CITY OF ALBUQUERQUE

Re: New Office Building
10601 Research Rd SE
Traffic Circulation Layout
Engineer's/Architect's Stamp 07-30-19 (M21-D021)

Based upon the information provided in your submittal received 08-12-2019, the above referenced plan cannot be approved for Building Permit until the following comments are addressed:

A1 TRAFFIC CIRCULATION LAYOUT
1/16" = 1'-0"

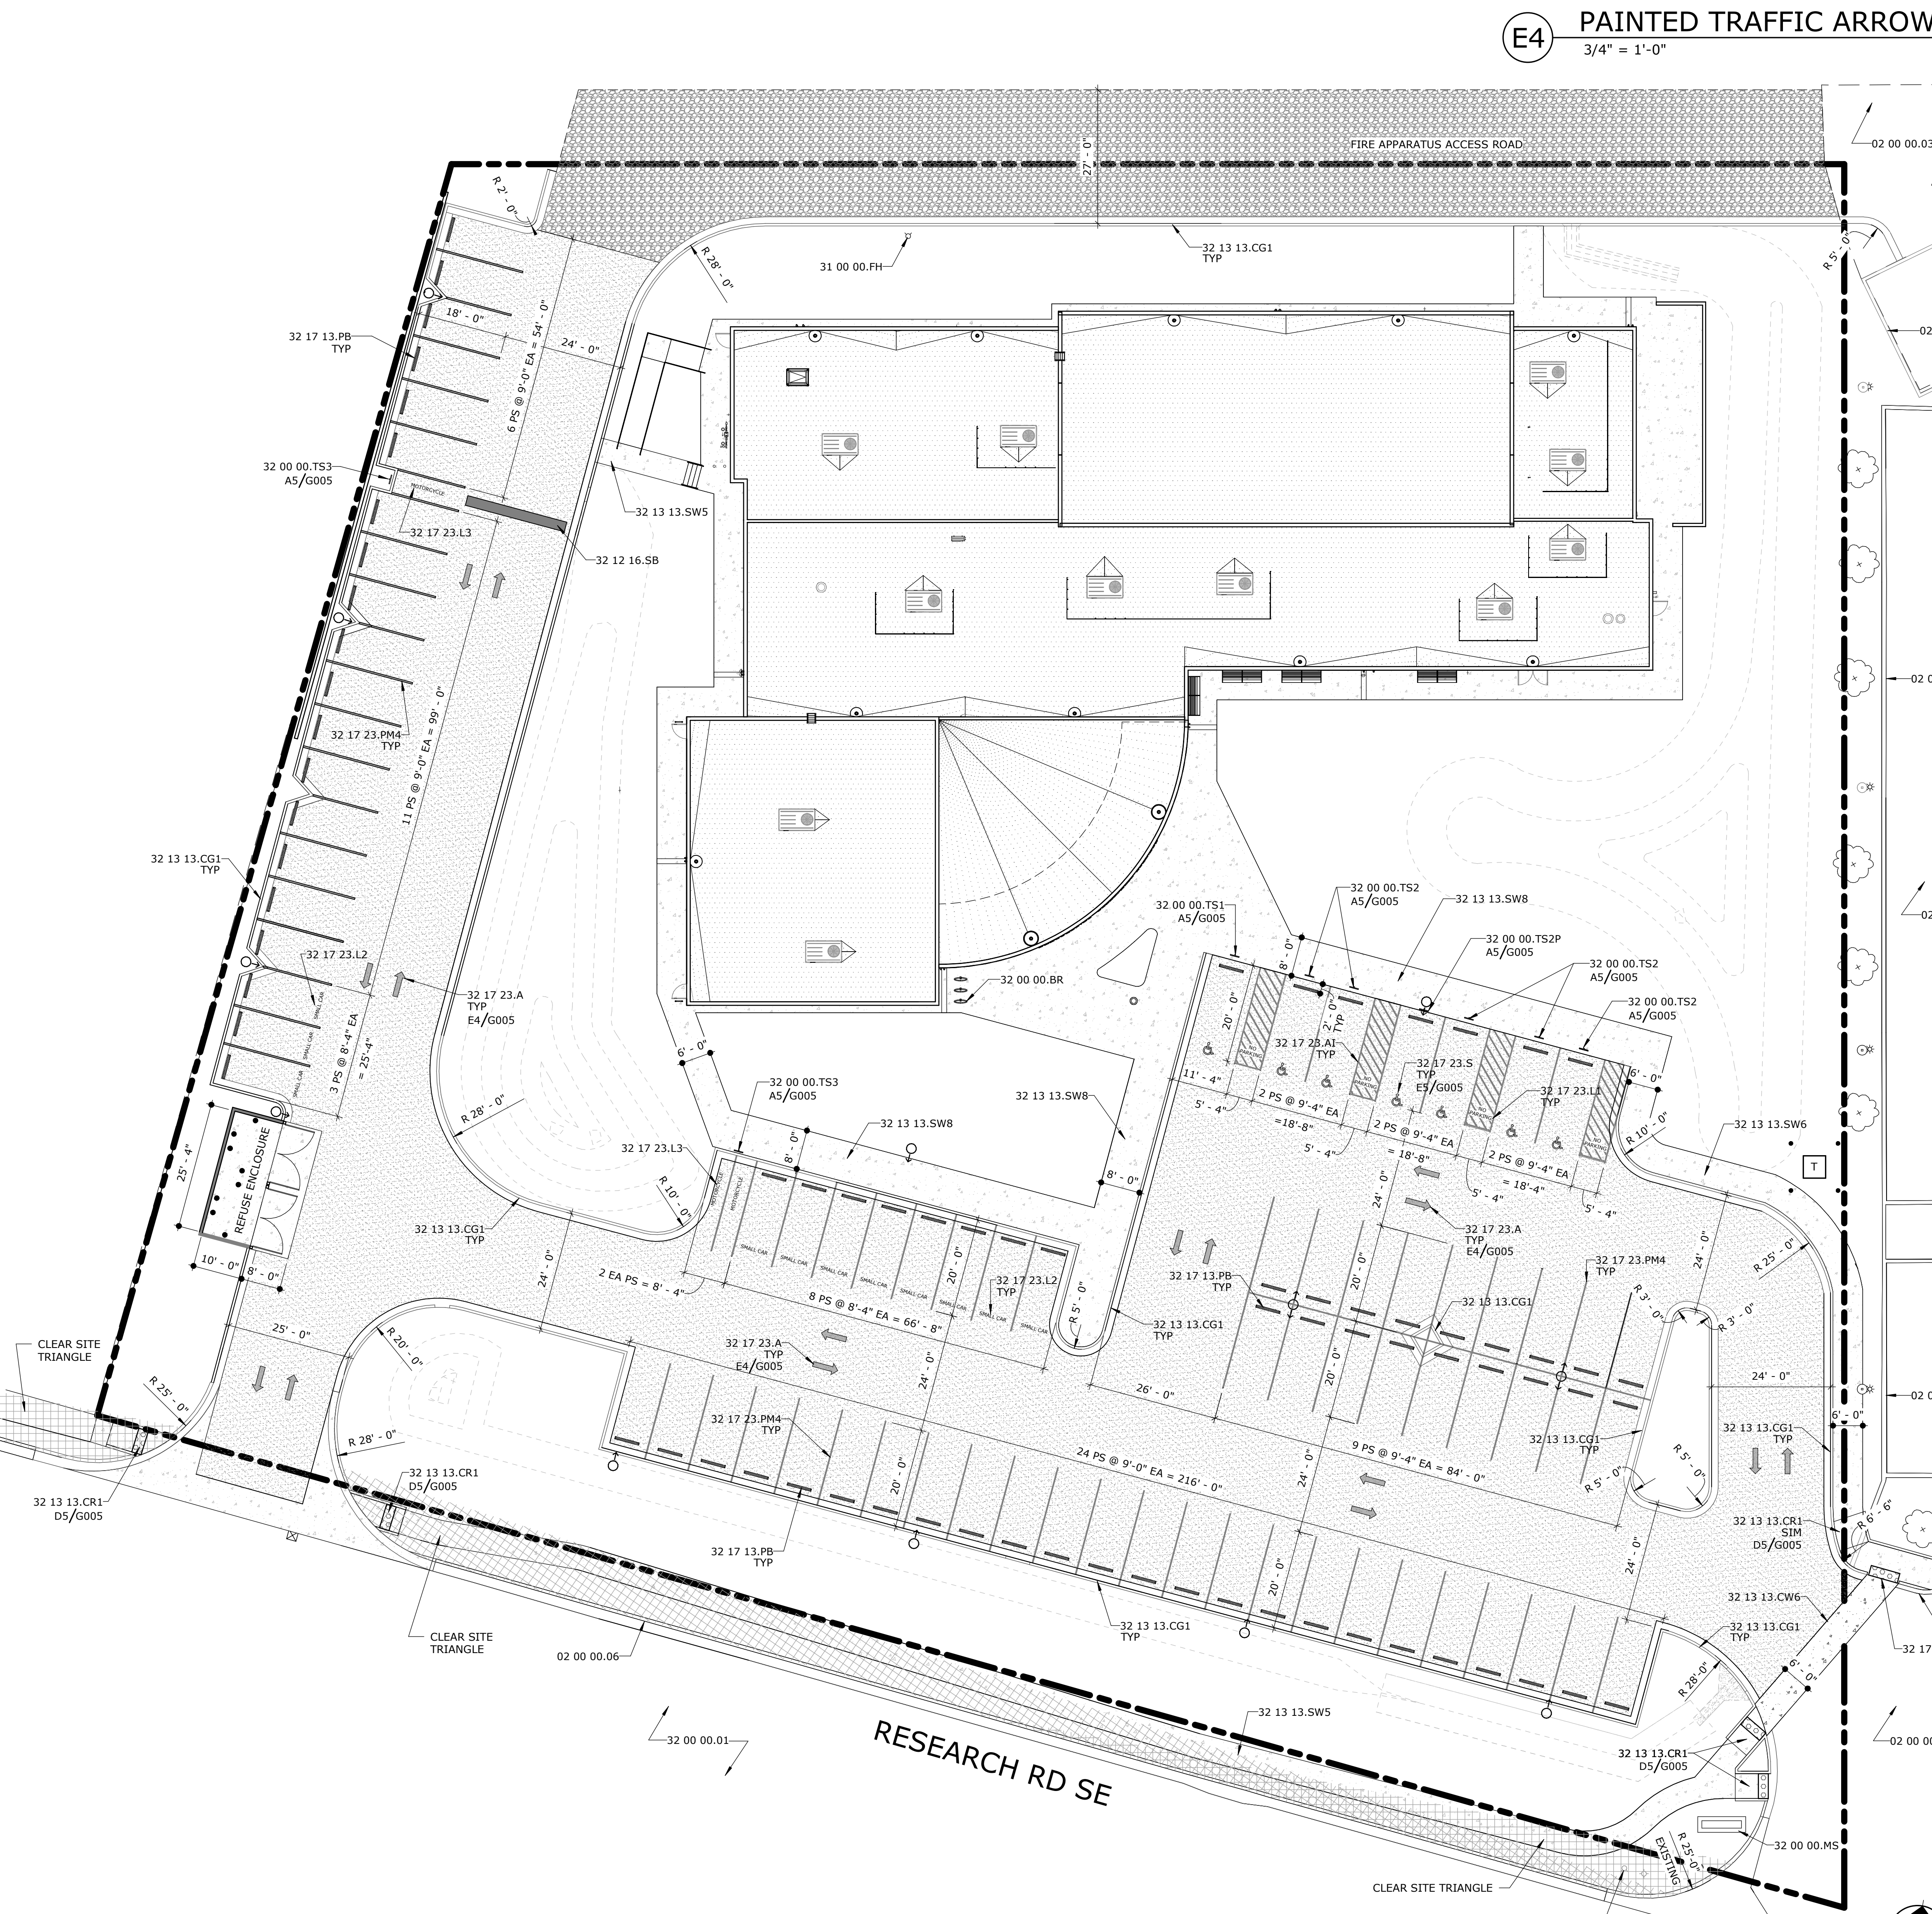
1. List the number of parking spaces required by the zoning code as well as the proposed number of parking spaces including bicycle and motorcycle parking.

2. Per the Development Process Manual, Chapter 27 Drafting Standards, "Standard sheets must be 24" by 36" having a margin of 2' along the left and 1"
3. Label the compact parking spaces by placing the words "**COMPACT**" on the pavement of each space.

4. All bicycle racks shall be designed according to the following guidelines:
 - a. The rack shall be a minimum 30 inches tall and 18 inches wide.
 - b. The bicycle frame shall be supported horizontally at two or more places. Comb/toaster racks are not allowed.

- c. The rack shall be designed to support the bicycle in an upright position. See the IDO for additional information.
 - d. The rack allows varying bicycle frame sizes and styles to be attached.

- e. The user is not required to lift the bicycle onto the bicycle rack.
 - f. Each bicycle parking space is accessible without moving another bicycle.

5. Bicycle racks shall be sturdy and anchored to a concrete pad.
6. A 1-foot clear zone around the bicycle parking stall shall be provided.
7. Bicycle parking spaces shall be at least 6 feet long and 2 feet wide.

8. Parking areas shall have barriers to prevent vehicles from extending over public sidewalk, public right-of-way, or abutting lots.

9. Refuse vehicle maneuvering shall be contained on-site. The refuse vehicle shall not back into the public right of way.; **provide a copy of refuse approval.**

10. It is not apparent what type of pavement surface is being proposed. A hard driving surface will be required as part of this proposed project for parking area and drive aisles.

11. Show the clear sight triangle and add the following note to the plan: "Landscaping and signage will not interfere with clear sight requirements. Therefore, signs, walls, trees, and shrubbery between 3 and 8 feet tall (as measured from the gutter pan) will not be acceptable in the clear sight triangle.

12. Shared Site access: driveways that straddle property lines, or are entirely on one property but are to be used by another property, shall have an access easement. Please include a copy of your shared access agreement with the adjacent property owner.
